ENGINE - FUEL AND CONTROL - FUEL SYSTEM TUBES - TUBE SUPPORT BRACKET ATTACHED WITH  
HEX-HEAD BOLTS - CATEGORY CODE 6 - MOD.ENG-73-0059

**V2500-ENG-73-0059**

## SERVICE BULLETIN

Location of clipping points 2057, 2060 and 2302  
Fig.1

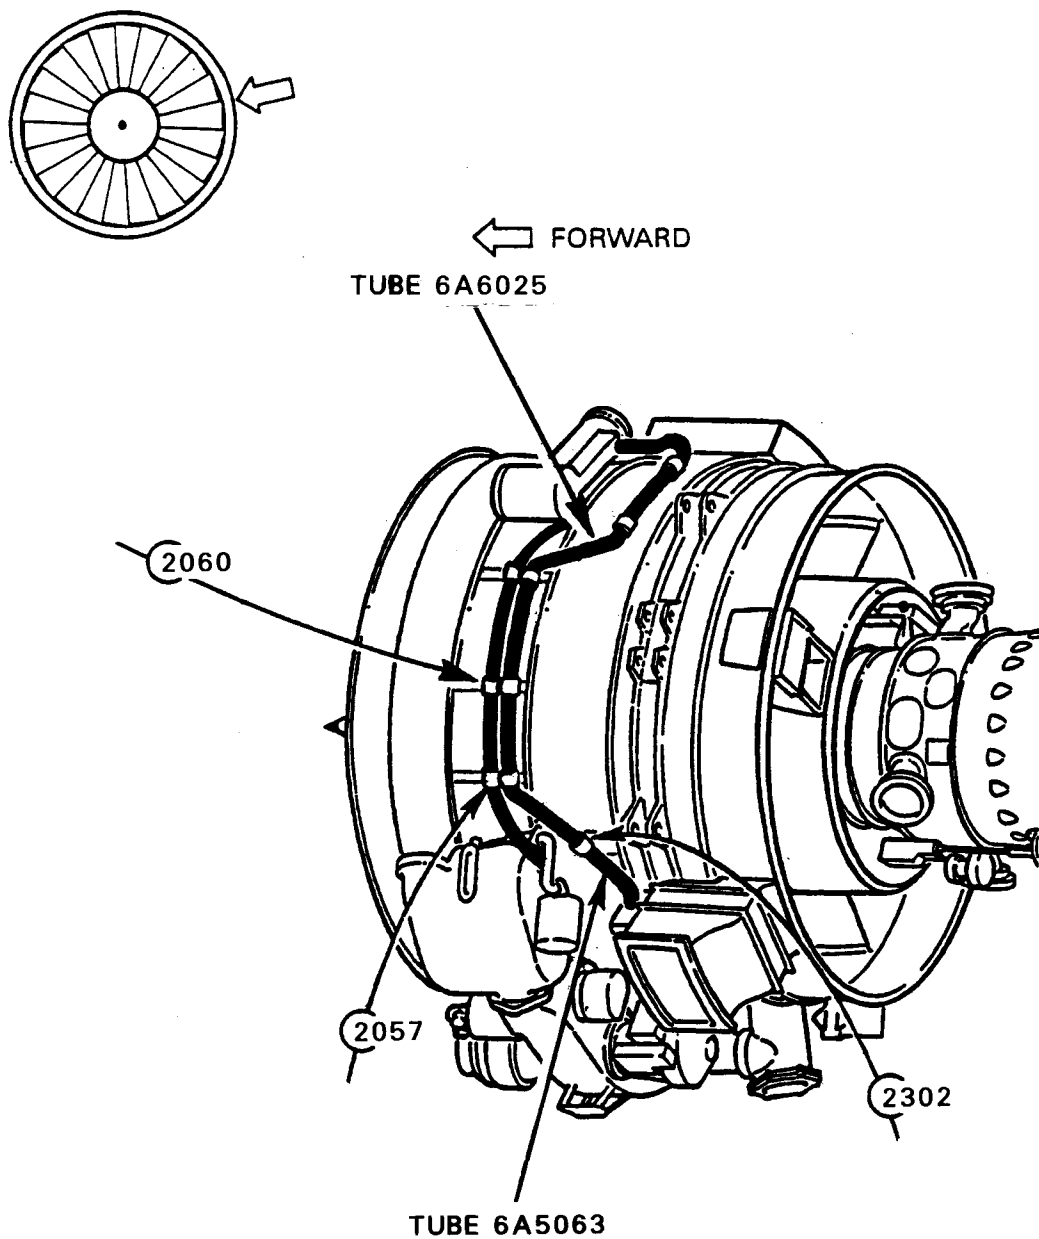
- (1) Find 6A5063 oil tube. Refer to Figure 1.
- (2) Disconnect the electrical connector from the scavenge oil temperature thermocouple.
- (3) Remove the AS21016 bolts (3 off) that attach the 6A5063 oil tube to the Air Cooled Oil Cooler. Remove the 6A5063 oil tube and retain the AS21016 bolts.

- (7) Raise the 6A5063 oil tube sufficiently to allow access to the AS21011 bolts (2 off) which retain the 6A4921 bracket to the 6A4922 bracket. Remove and discard the AS43013-118 sealing ring from the 6A5063 oil tube. Refer to Figures 1 and 2.

View on bracket raft assembly showing location of modified bolts - Before and after alteration  
Fig.2

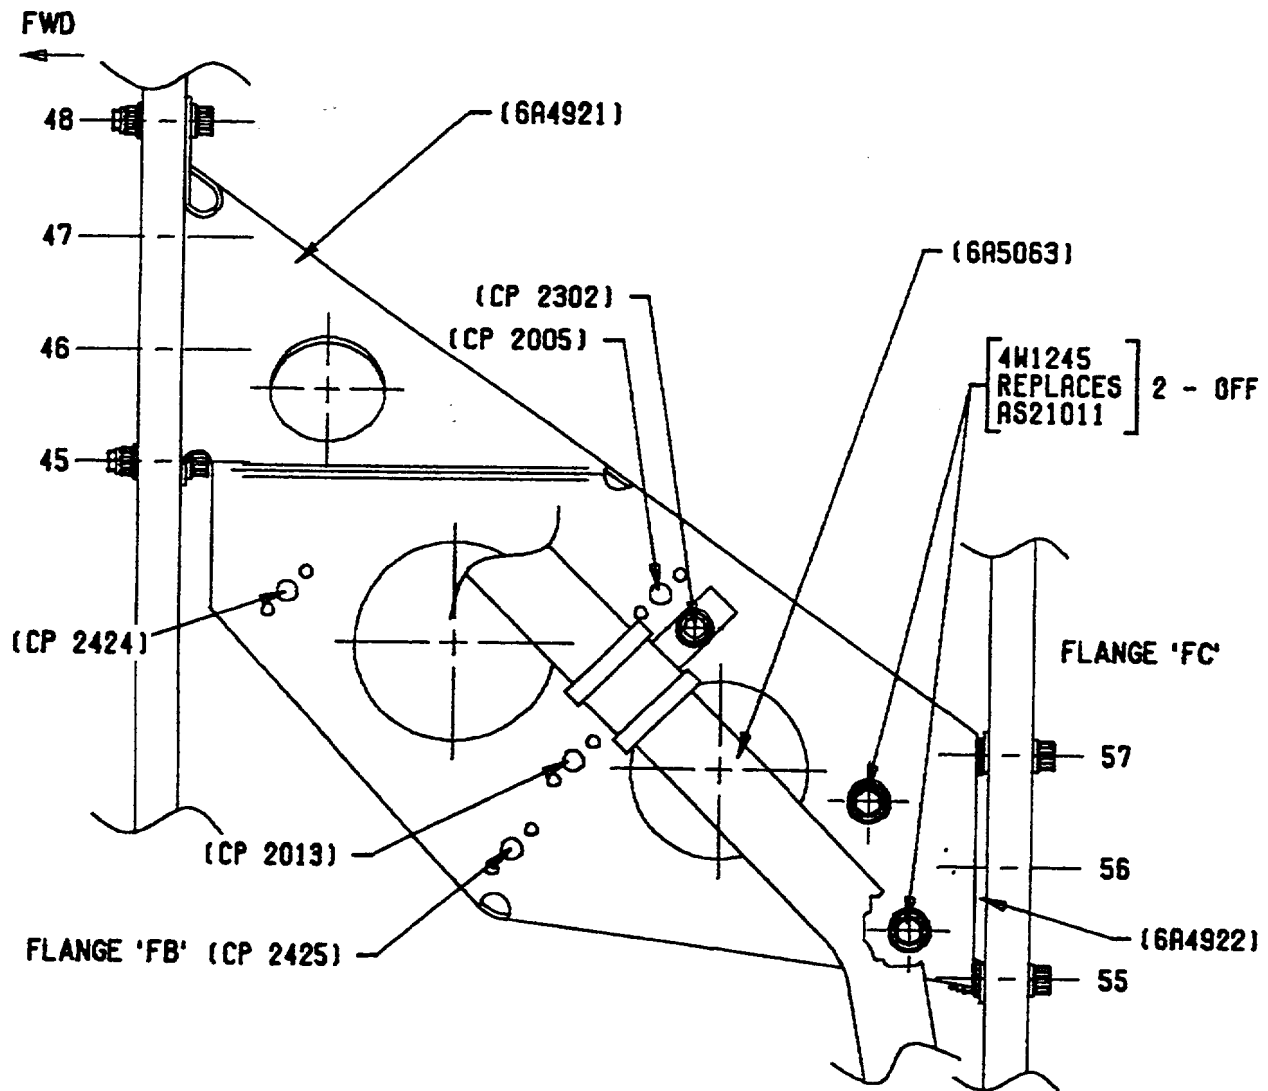
Limited clearance exists between the Air Cooled Oil Cooler to Fuel Cooled Oil Cooler oil tube and tube support bracket retaining bolt heads.

To eliminate possible bolt head foul on oil tube.

- (1) The tube support bracket bi-hex bolts are replaced with hex-headed bolts.

- (8) Remove the AS21011 bolts (2 off) and 4W2622 washers (2 off). Retain the washers, discard the bolts. Refer to Figure 2.
- (9) Install the new 4W1245 bolts (2 off) and 4W2622 washers (2 off). Torque the bolts to 85 to 105 lbfin (10 to 12 Nm). Refer to Figure 2.
